File No. D07-12-17-0162

**Subject: Technical Circulation Comments
Site Plan Control Application: 3058 Jockvale Road**

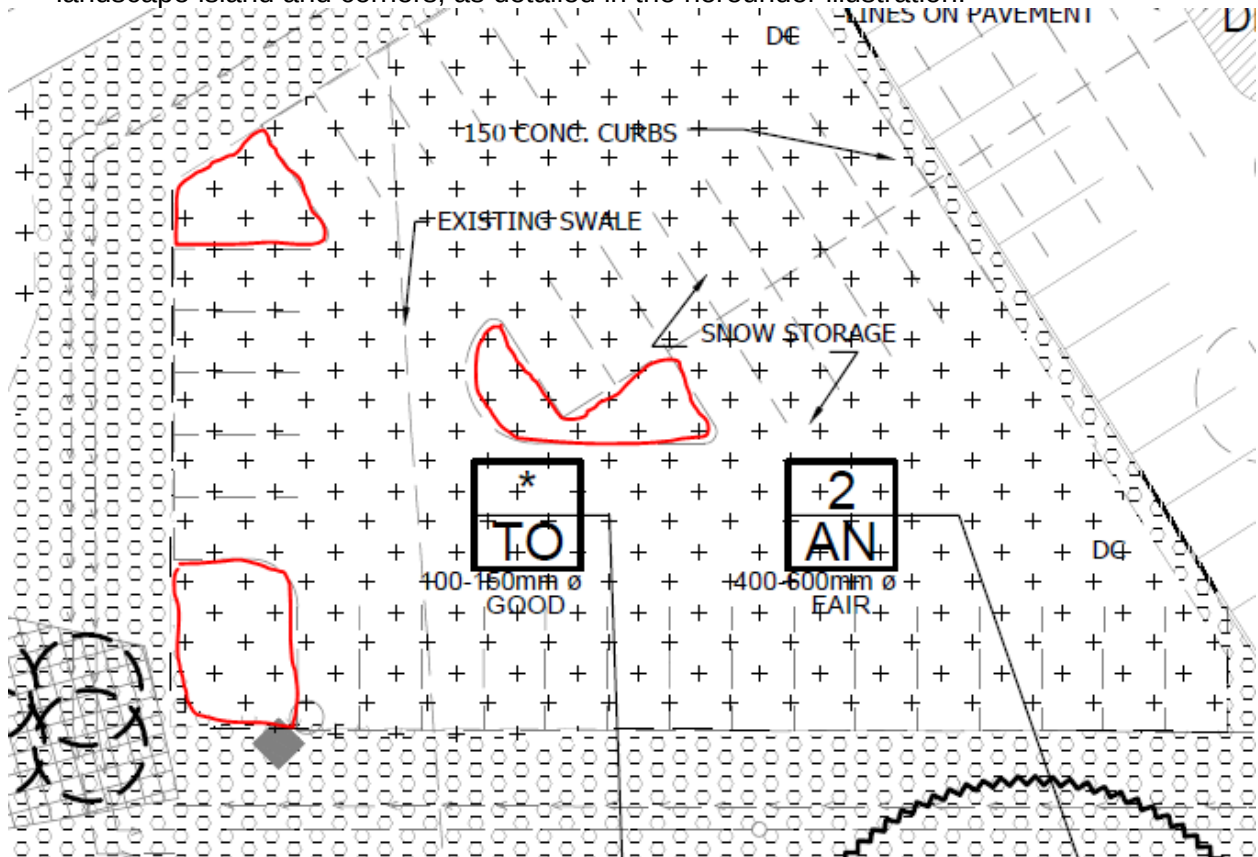
4. Show the 'future proposed seeded grass area' in the future phase parking, e.g., landscape island and corners, as detailed in the hereunder illustration.

The landscape plan has been revised to show future proposed seeded grass area and the revised handicap parking layout.
